ARCHITECTURAL REVIEW BOARD STAFF REPORT

Project #/Name	SP-2023-21: Flow Hyundai Outdoor Storage, Display, and Sales
Review Type	Advisory Review for a Special Use Permit
Parcel Identification	04500-00-00-068C0
Location	On the west side of Rt. 29, approximately 1280' south of the Rt. 29/Hilton Heights Rd. intersection.
Zoned	Highway Commercial (HC) / Entrance Corridor (EC) / Airport Impact Area (AIA)
Owner/Applicant	TAP Investments LLC / Shimp Engineering (Kelsey Schlein)
Magisterial District	Rio
Proposal	To establish outdoor storage, display, and sales of vehicles in association with the construction of an auto dealership consisting of two showrooms with service bays and associated site improvements on approximately 5.72 acres.
Context	The property is vacant and mostly wooded. The east and west perimeters of the parcel are bounded by Rt. 29 and Berkmar Drive with automobile dealerships to the north and south of the subject property. (Fig. 1.)

Figure 2: Proposed concept plan showing the layout of buildings, travelways, vehicle storage and display areas, and parking.

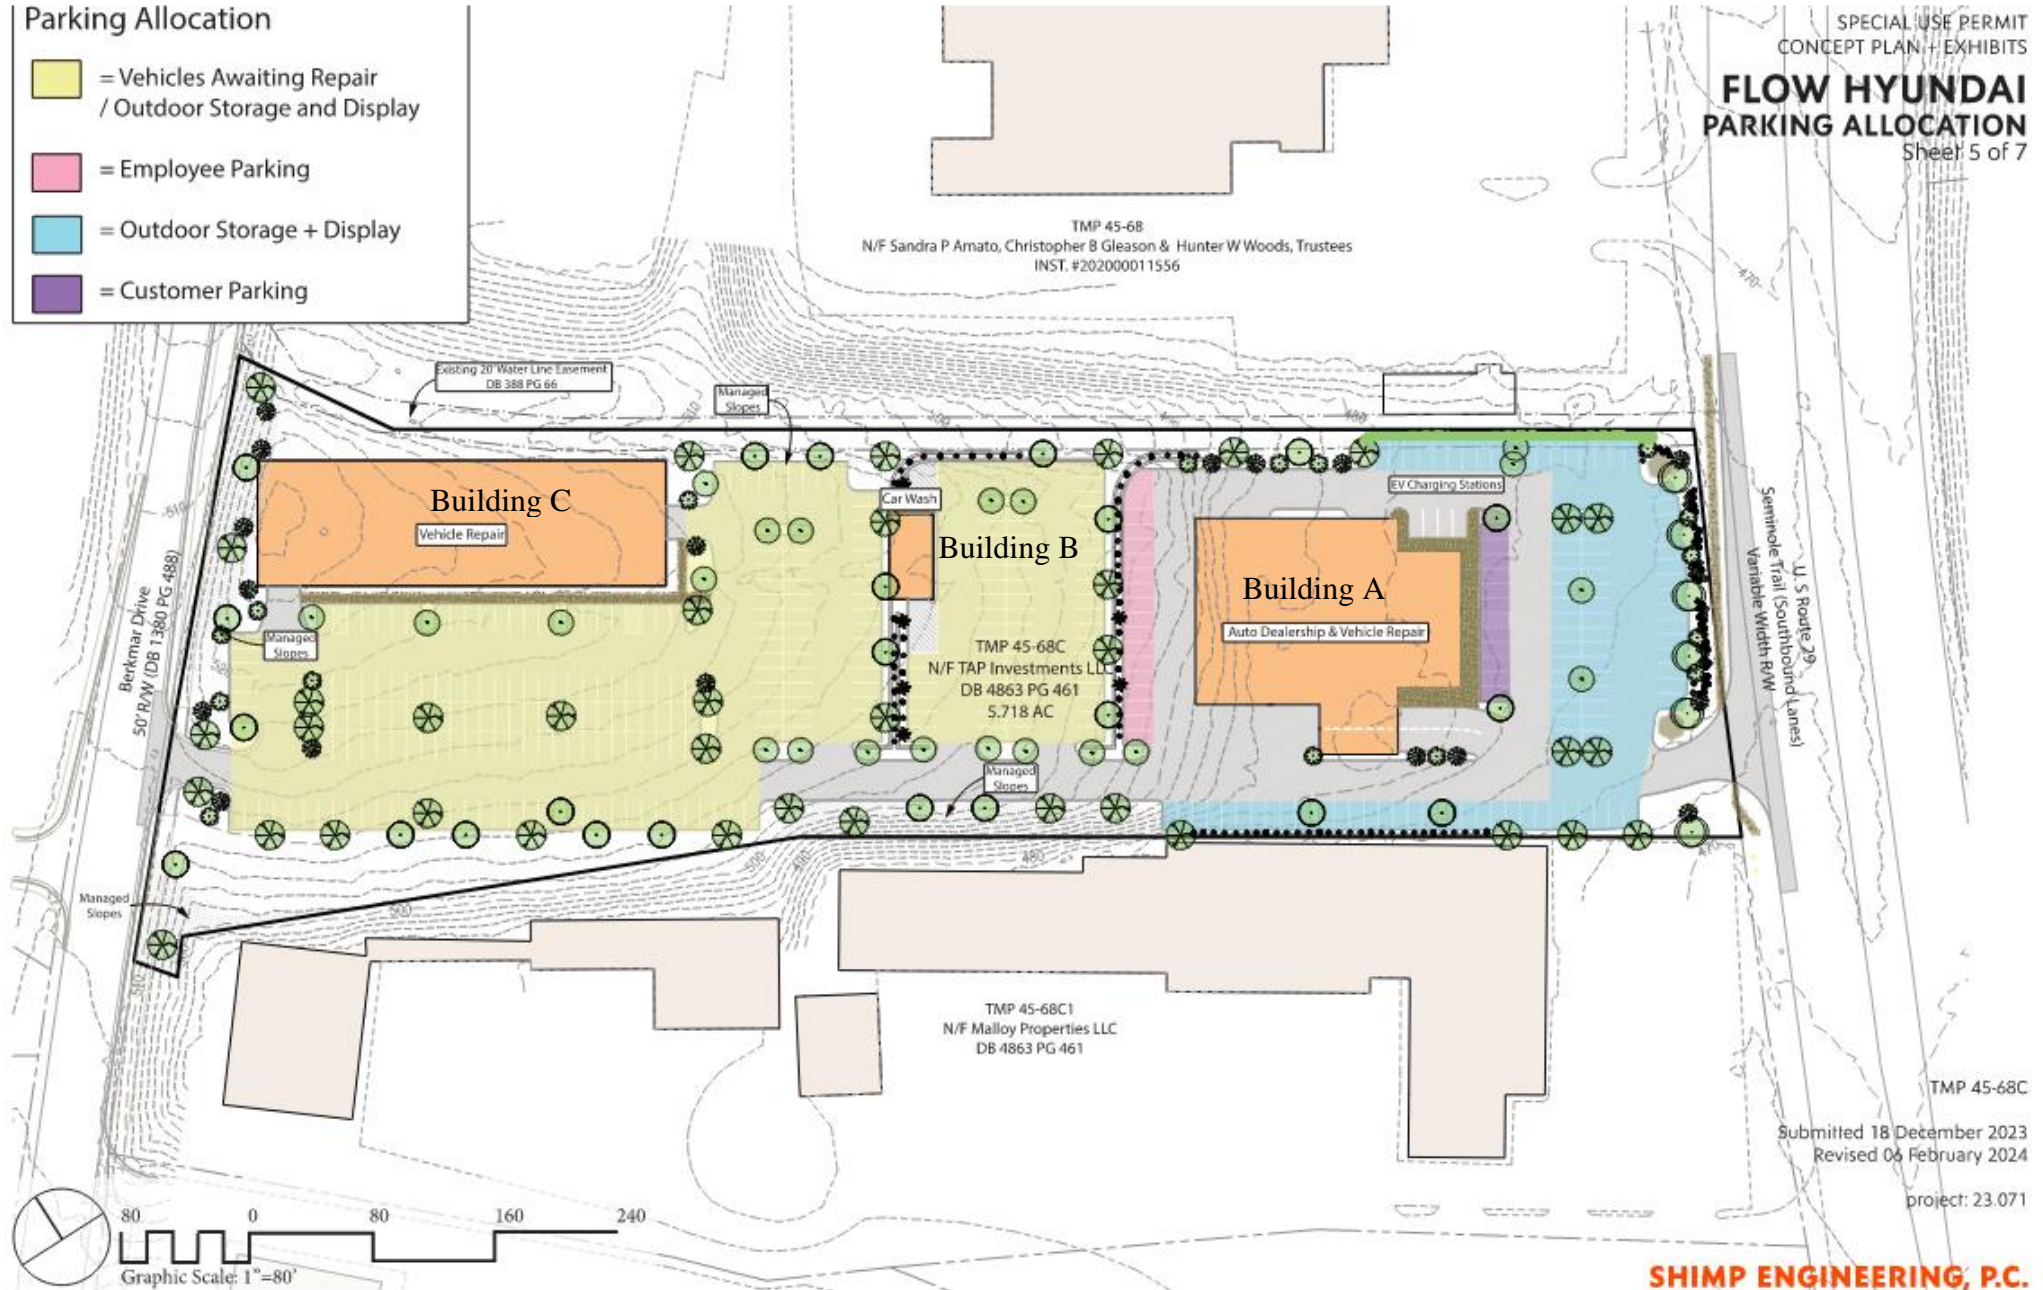
1. The extent to which proposed landscaping mitigates the visual impacts of the storage, display and sales parking.
 - a. The depth of the planting area along Rt. 29.
 - b. Landscaping along parking lot perimeters.
 - c. Distribution of interior parking lot trees.

1. Revise the concept plan to show the easements and show that there are no conflicts.
2. Revise the concept plan to show increased landscaping south of the site entrance along Rt. 29.
3. Revise the concept plan to provide additional tree islands in the northern and southern parking rows at 40’ on center.
